May 2017 VVX 500 Product Shipping Change Notice

Engineering Advisory 92279

This engineering advisory provides details about product shipping changes planned for May 2017 to Polycom® VVX® 500 Business Media phones. This notice is up to date as of April 21, 2017.

VVX 500 Console Label and Revision Code

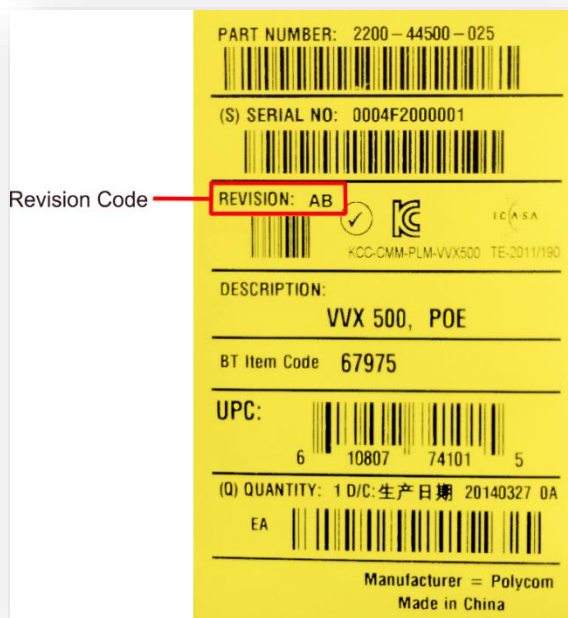
You can confirm that your VVX 500 phone includes the new display component by viewing the revision code listed on the rear of the phone and revision code listed on the colored shipping box label, as shown in the following figures [VVX 500 Console Label and Revision Code](#) and [VVX 500 Shipping Box Label and Revision Code](#). This notice is updated to reflect the actual revision codes as information becomes available.
